RE: Remarkables Ski Area Upgrades and Doolans Expansion – Response to Landscape Feedback

PEER REVIEW MEMORANDUM REGARDING LANDSCAPE AND VISUAL EFFECTS ASSESSMENT

DOC Memorandum on NZSki Landscape Effects Assessment

Note: These exports from the 3D terrain model have not undergone any image editing and are not equivalent to visual simulations of the proposal. While accurate based on the modelling of earthworks and proposed structures, mesh lines between terrain tiles remain visible (light grey lines).

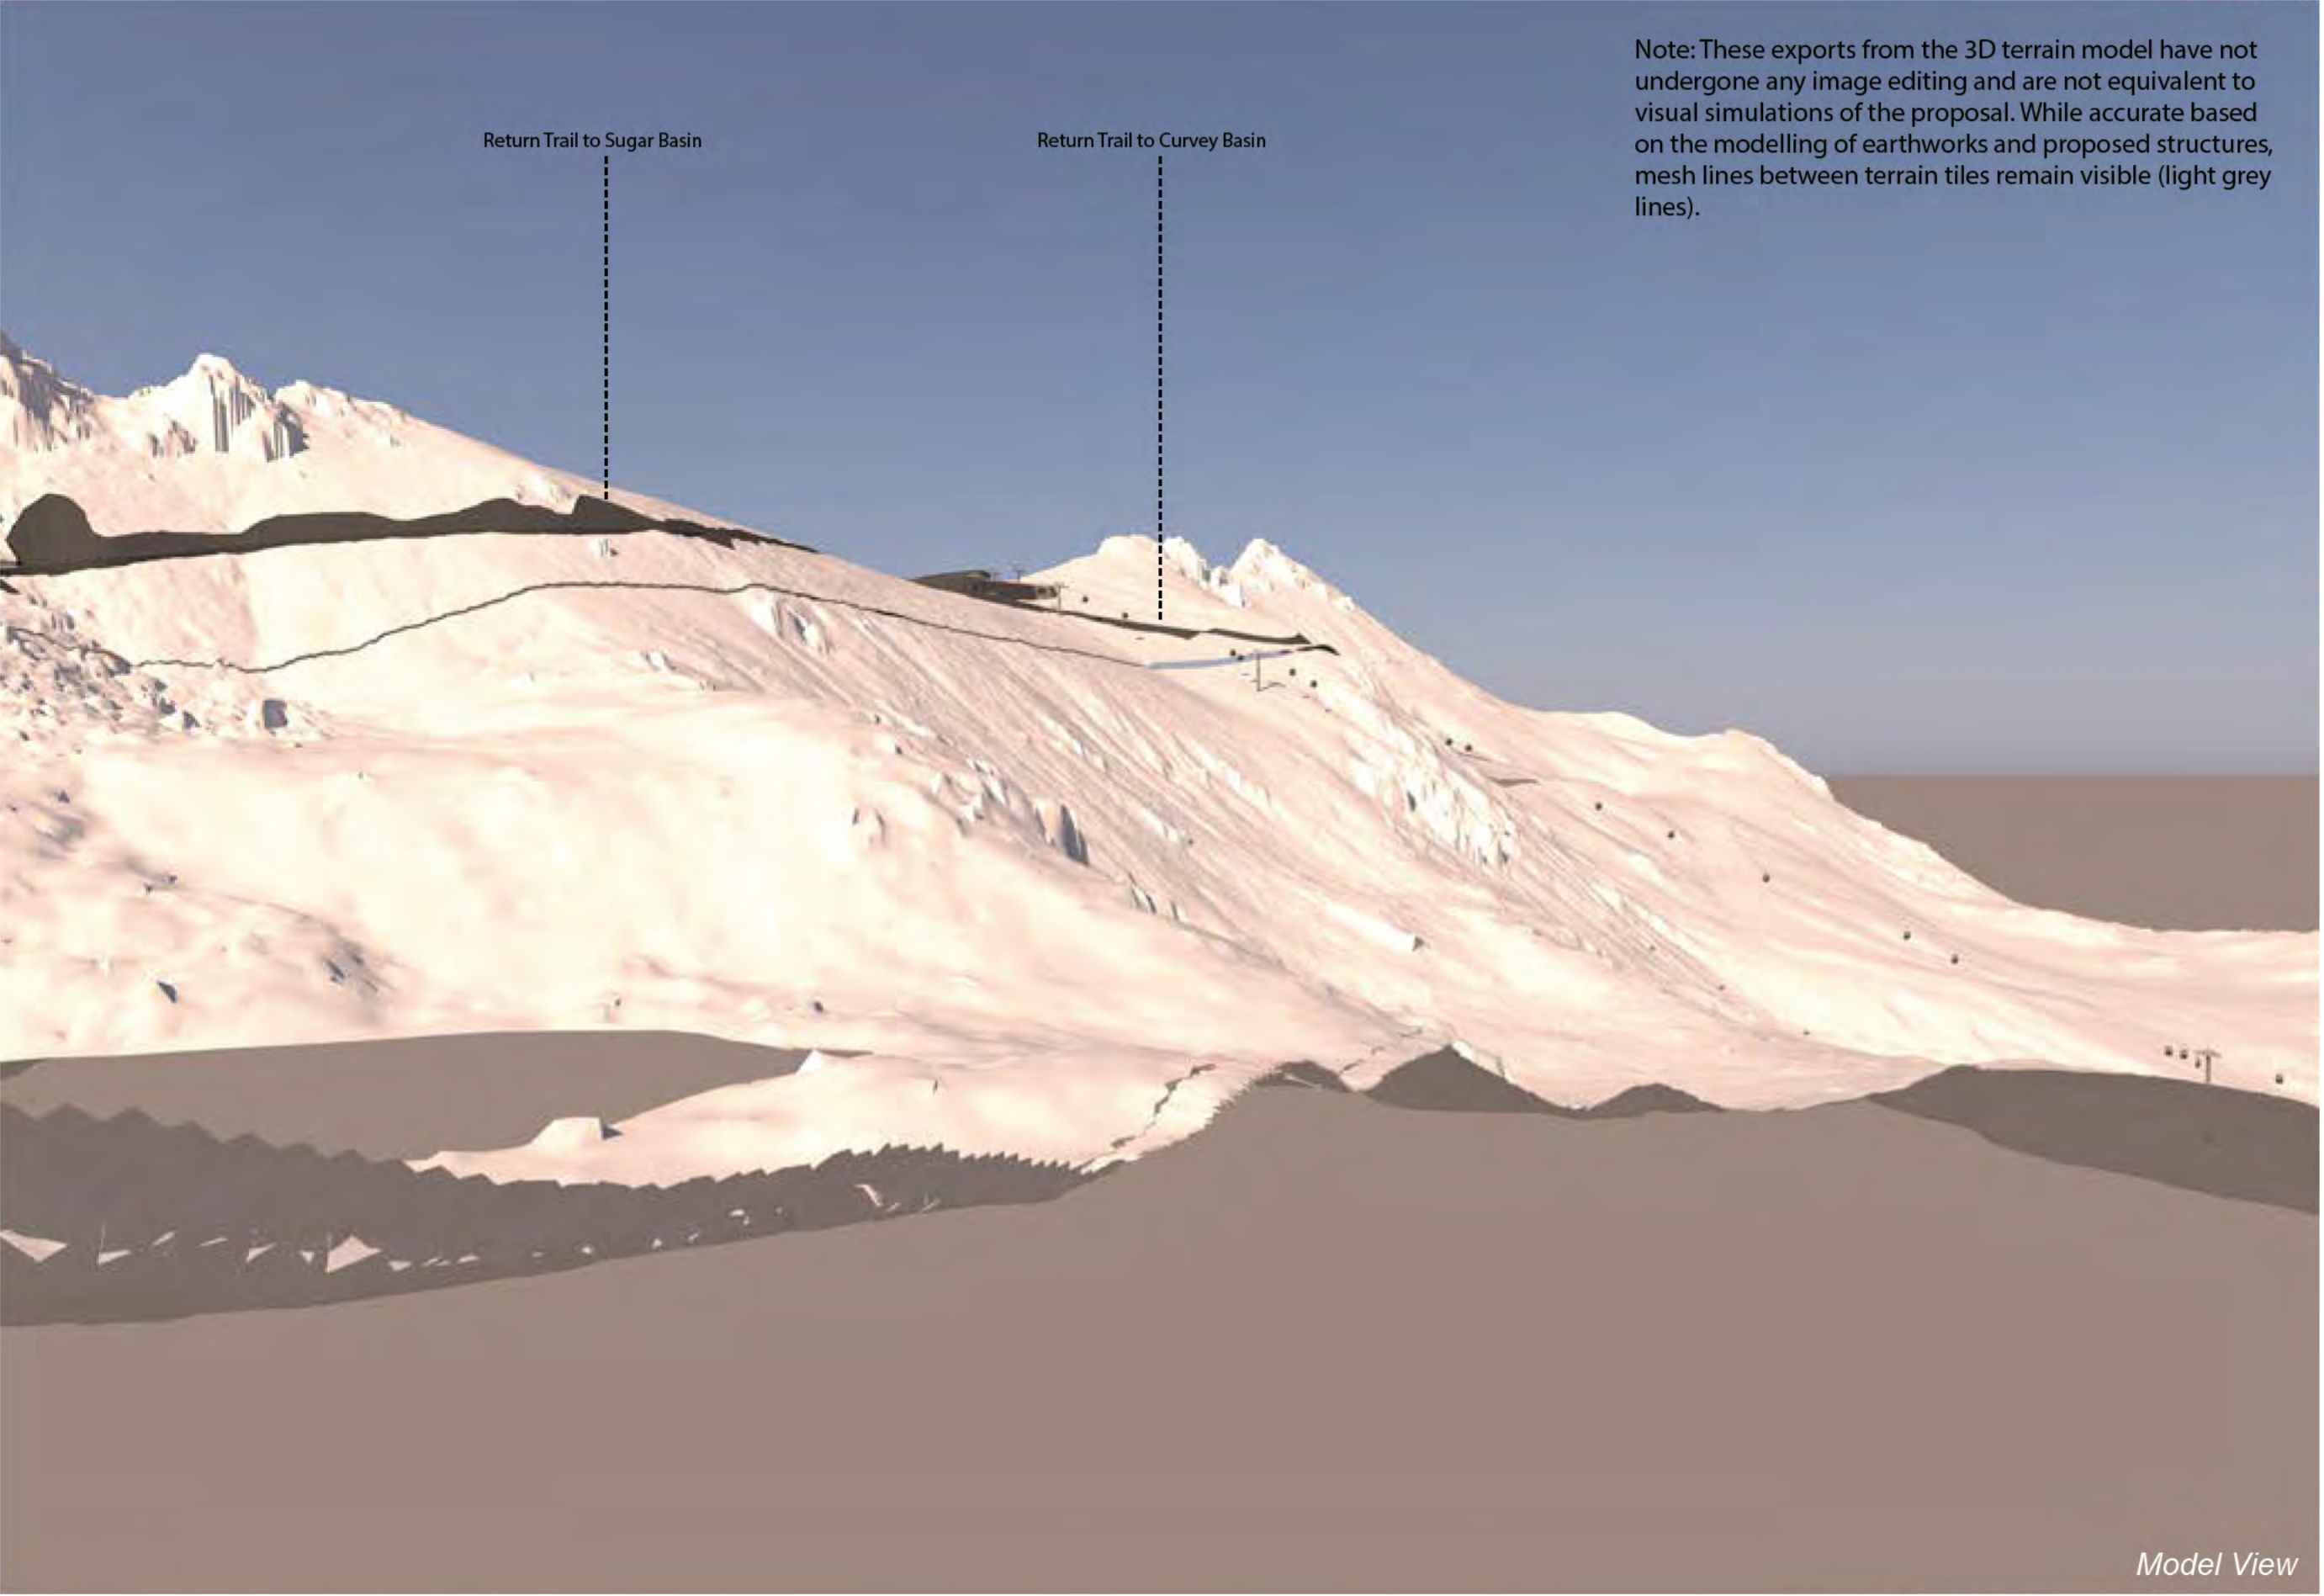
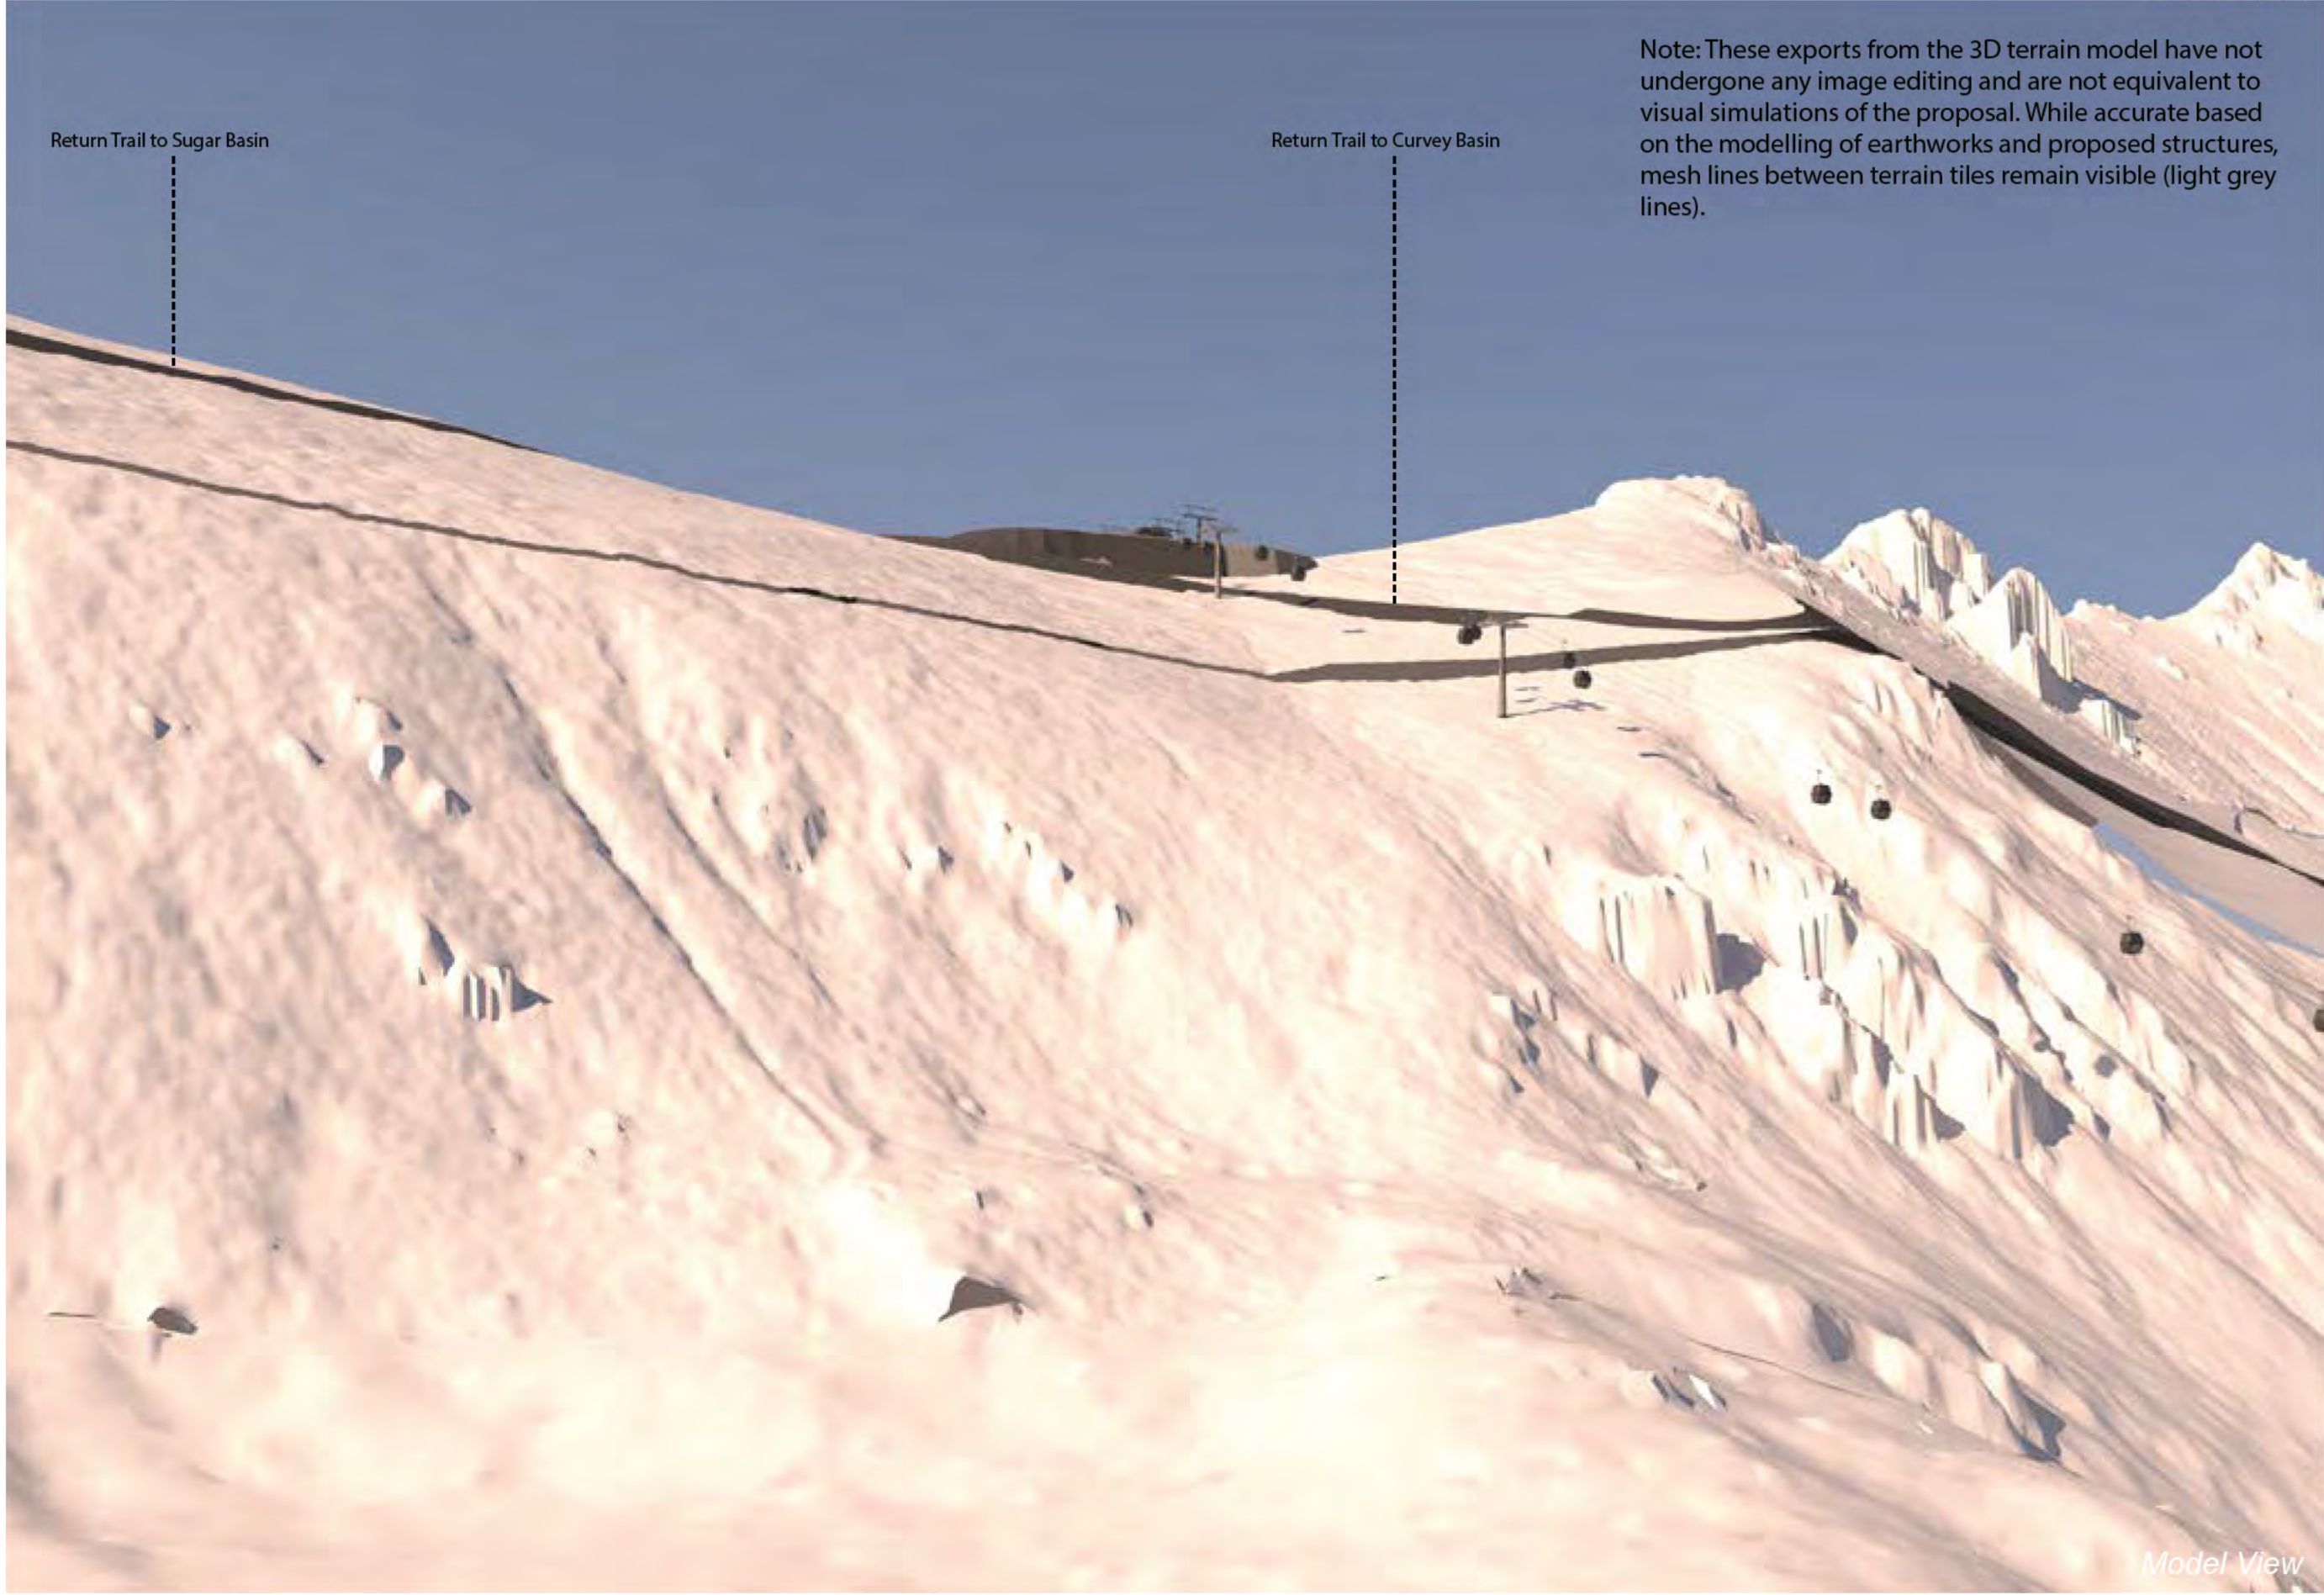
2. NZSki to provide views of the proposed mid-station in relation to the surrounding landform and landscape context.

19. The mapping in the 6 May 2026 B-031.1 Remarkables Ski Area Upgrade and Doolans Expansion Landscape Graphics (Figures 1, 2 and 4) is at a scale / level of detail where it is difficult to see where the proposed gondola mid-station is located. It is important that the various areas (QLD area and its mapped SASZ, the COD area, Rastus Burn Recreation Reserve and ridgeline) are accurately mapped along with the location of the mid-station building.

- > See attached Boffa Miskell memo and graphic supplement (**Attachment 3**)

The additional exports show both the mid station building and the earthworks required to establish the structure, including the proposed retaining walls and lift towers. In views within the ski field (see pages 1-10) the platform/retaining wall and lift tower will partially appear on the skyline, with the midstation structure itself largely out of view. For more distant views, the midstation will partially appear on the skyline (see visual simulation 3). However, in these views the structure is a comparatively small element.

On the Doolans side of the ridge the midstation is within a up to 10m high cut, but in nearby views from immediately below the structure (see Model view p.18) the mid station would protrude on the skyline. However, as shown in the ZTV, the mid station is obscured from substantial parts of the Doolans basin by intervening ridgelines. Pages 13-16 illustrate views of the mid station in views along the ridgeline to show the cut (Doolans side) and fill (Rastus Burn side) required to construct the platform. It is acknowledged that the visual effects of the mid station will be high when viewed within its immediate context along the ridge or from immediately below on the Doolans side. However, I maintain the view that visual effects of the mid station from the Rastus Burn side are mostly moderate, as the retaining wall partially obscures the structure in short-distance views and in long-distance views the structure is a relatively small element on a rocky ridgeline.
